SUBJECT: 25-040 Loaf Land Subdivision - Comment Response

Thank you for your review of the Subdivision Application Permit (SP 4103) for Loaf Land Subdivision in Coplin Plt.. The team recently received review comments from LUPC in regard to this application, dated July 1, 2026. These comments can be seen below in *italic*, followed by Main-Land's response in regular typeset. For the reviewer's ease, we have provided a new printed and PDF copy of the application with the additional and/or updated materials associated with this submission.

**STREAM PLAN &
PROFILE**

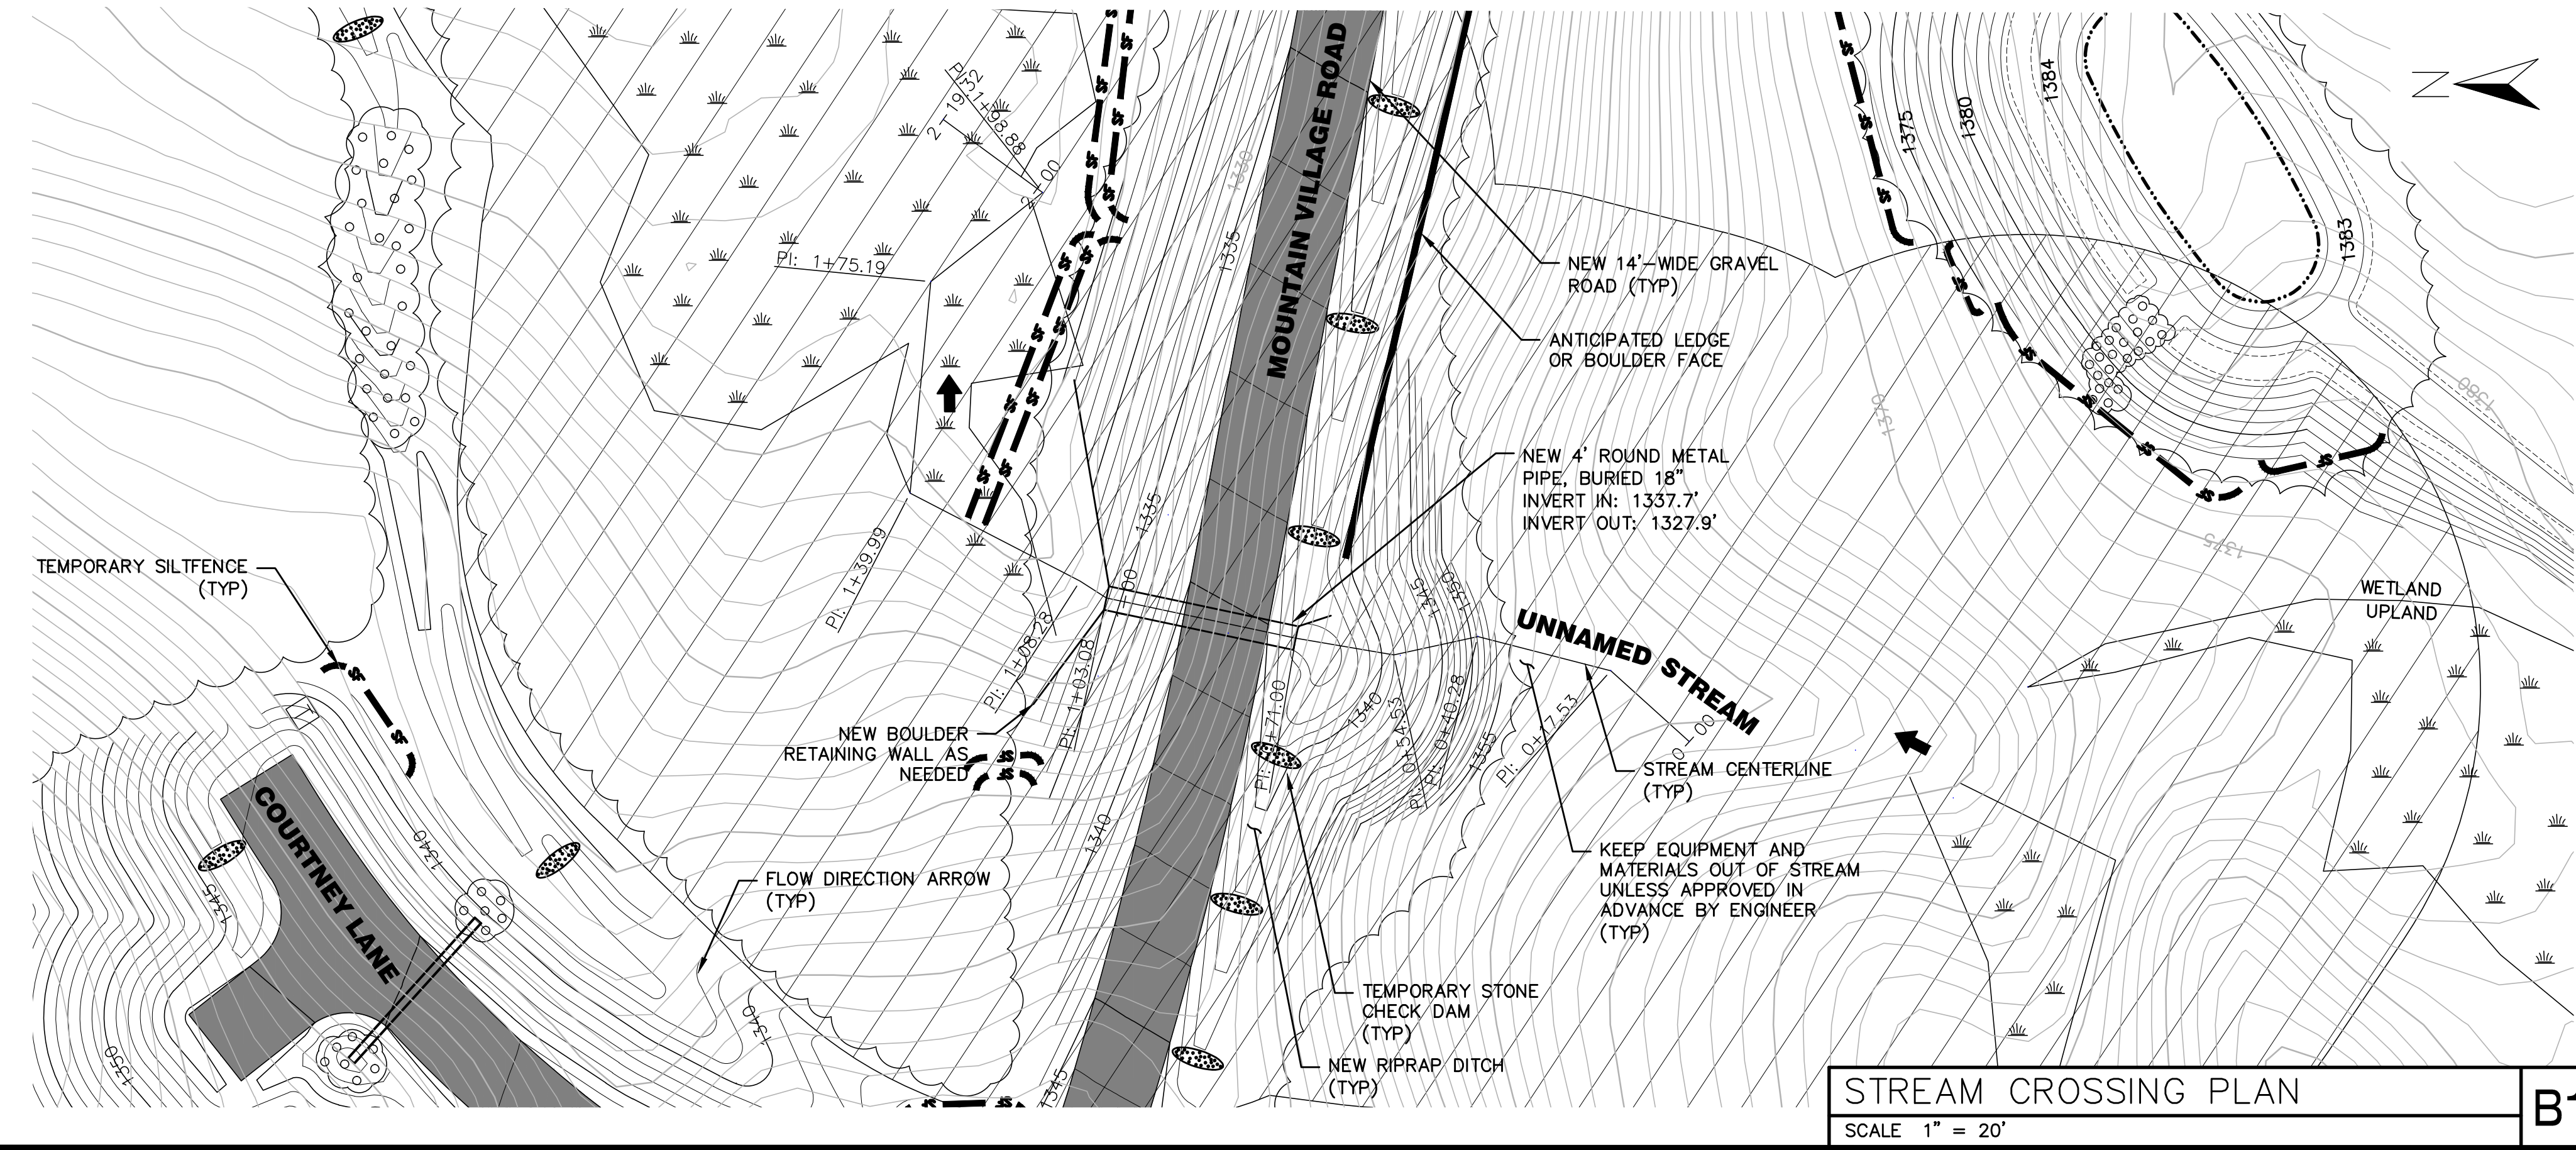
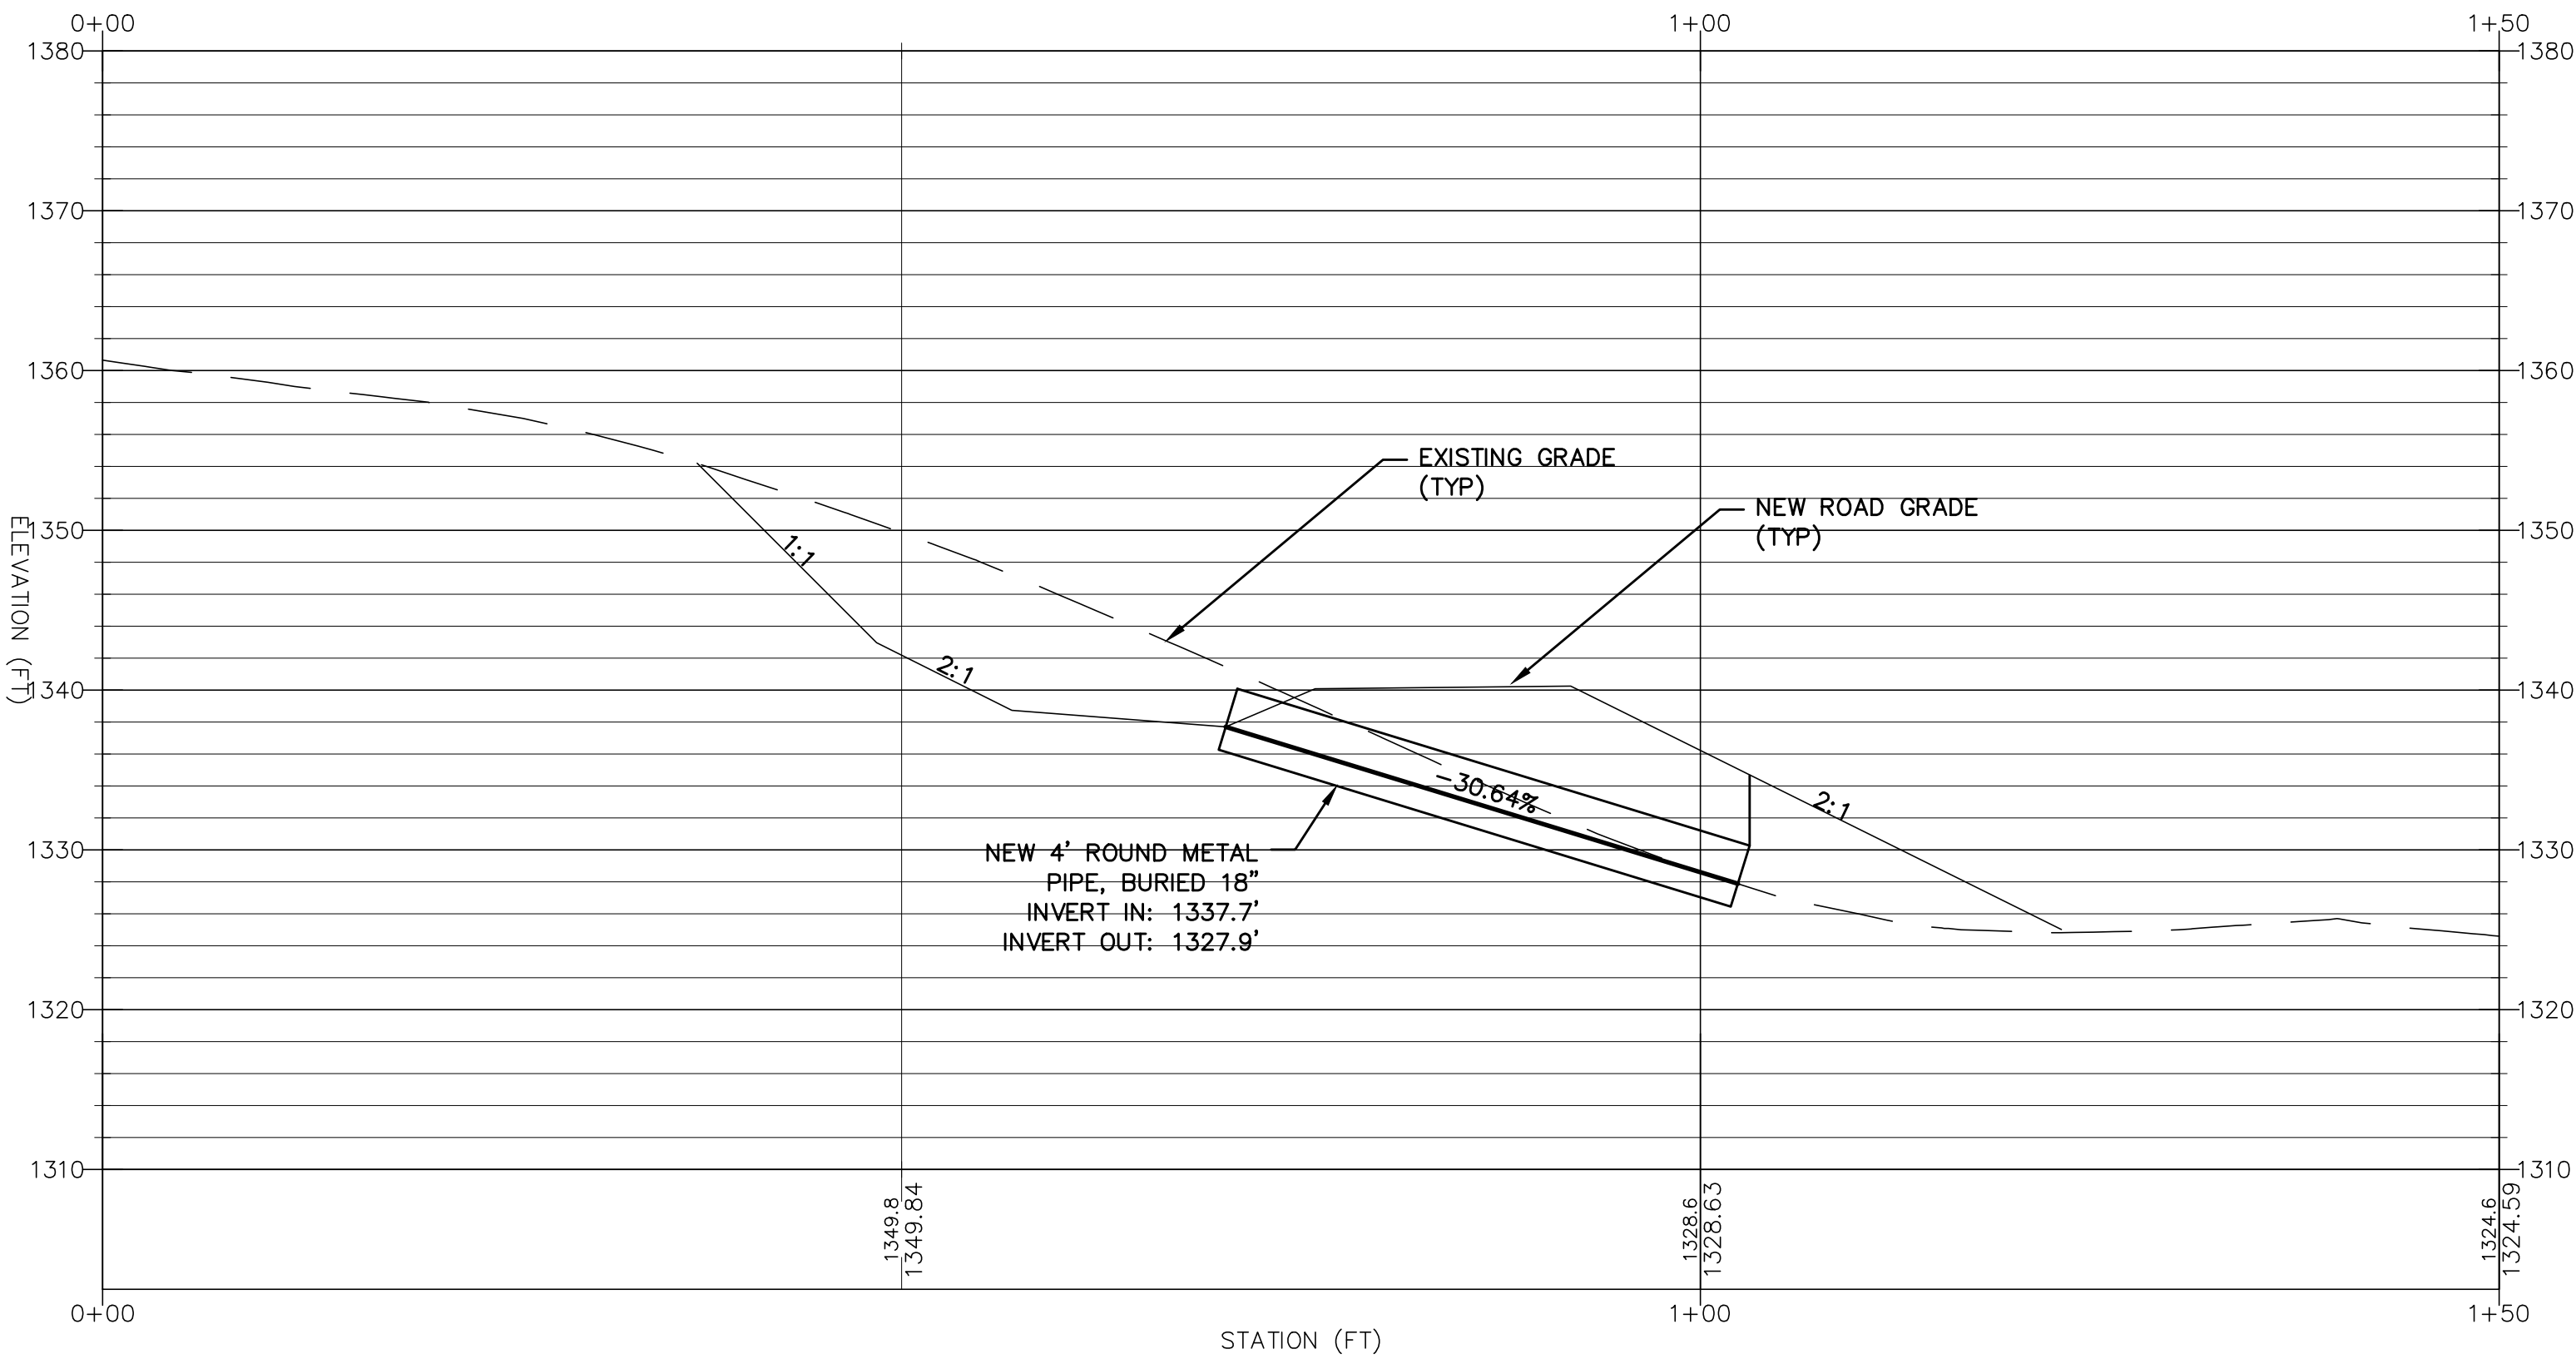
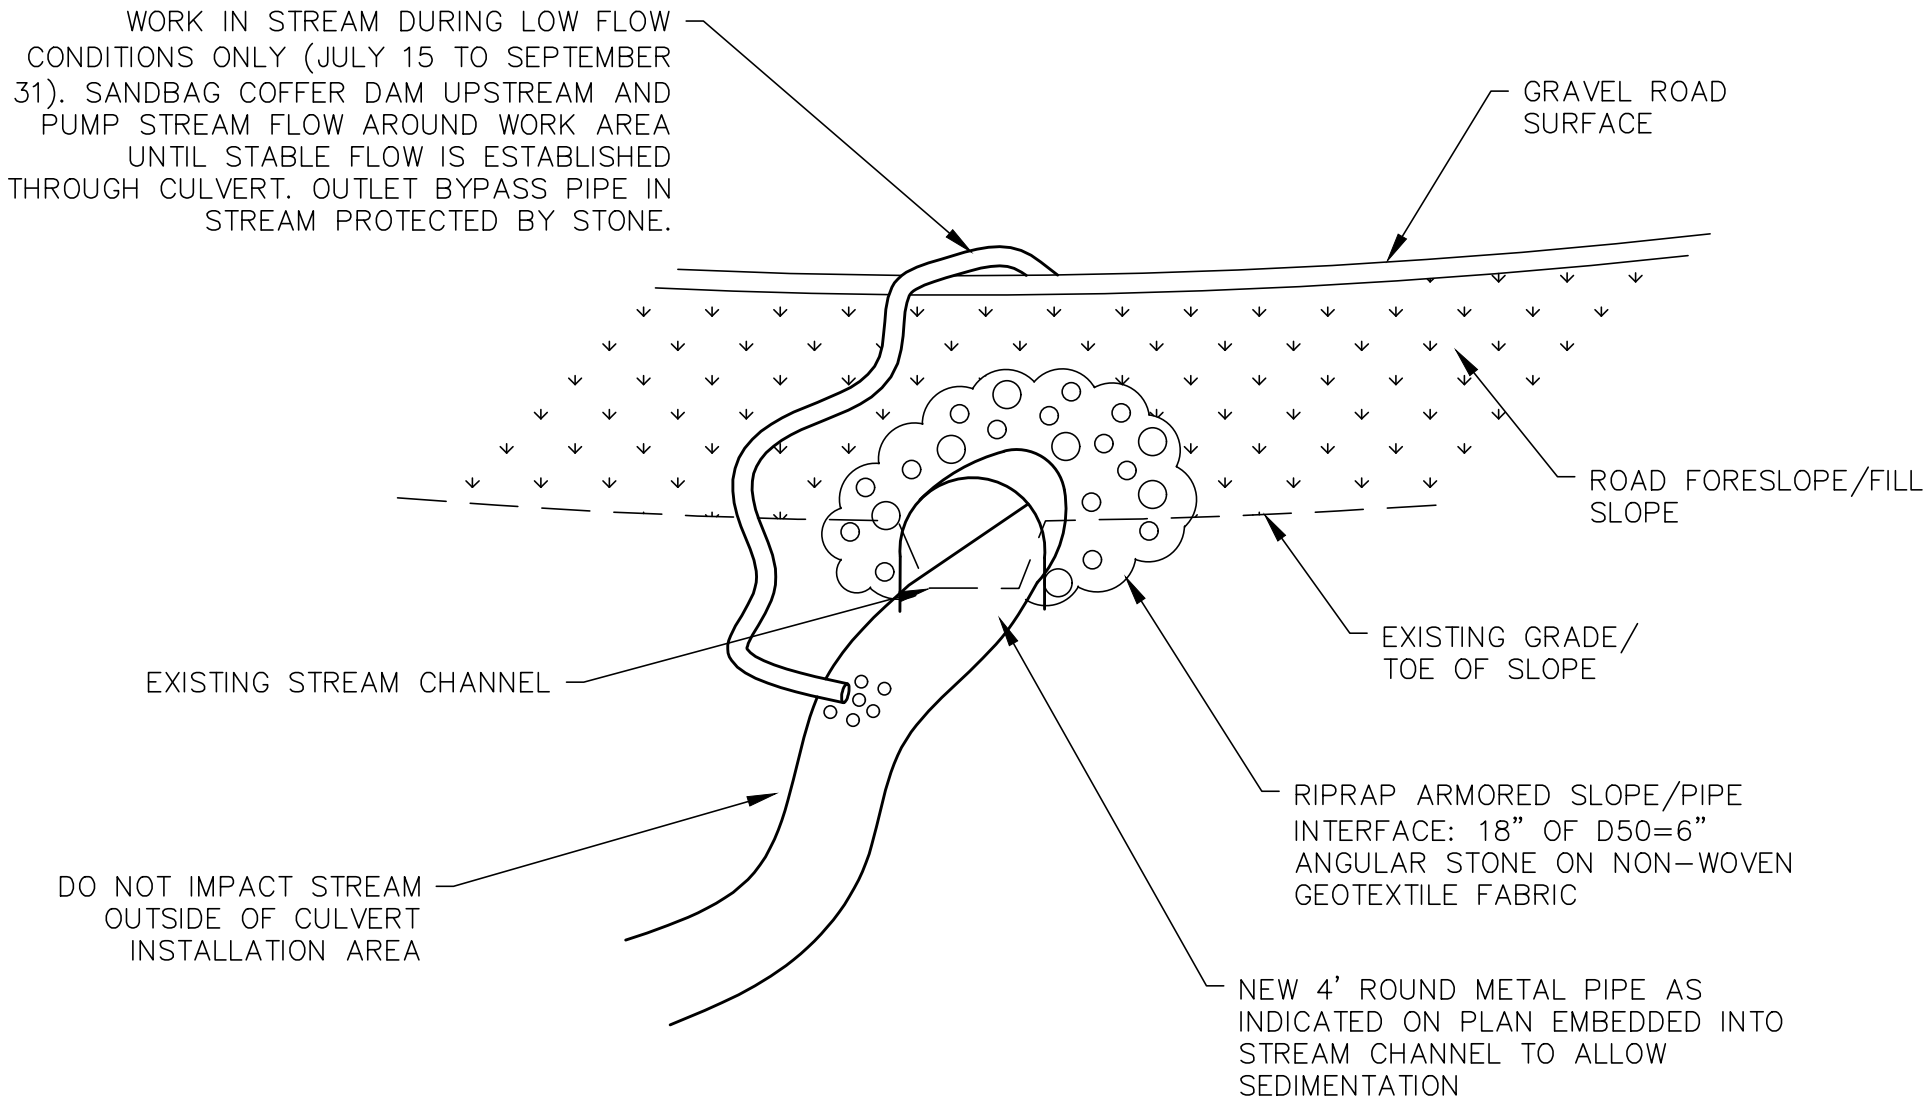
o *Sheet C5.3 – Stream Plan and Profile*

- *Address comments IV.9, 10, and 11 in the review by Sebago Technics*
 - IV. 9. Invert elevations should be provided for the stream crossing on the sheet C5.3 “Stream Plan and Profile”. The pipe should be evaluated for cover on the inlet side as the top of the pipe appears to be equal to the proposed road grade on the profile.*
 - IV. 10. On Sheet C5.3, the stream crossing plan does not show existing contours, and a boulder headwall is shown on both the outlet and inlet side. A detail showing the headwall end condition should be added to the stream crossing plan.*

IV. 11. On Sheet C5.3, there appears to be a 1:1 slope uphill of the inlet side of the stream crossing. It is unclear what this slope will consist of and does not match the proposed ground shown in the stream profile.

Plan C5.3 Stream Plan & Profile has been updated to reflect the above comments.
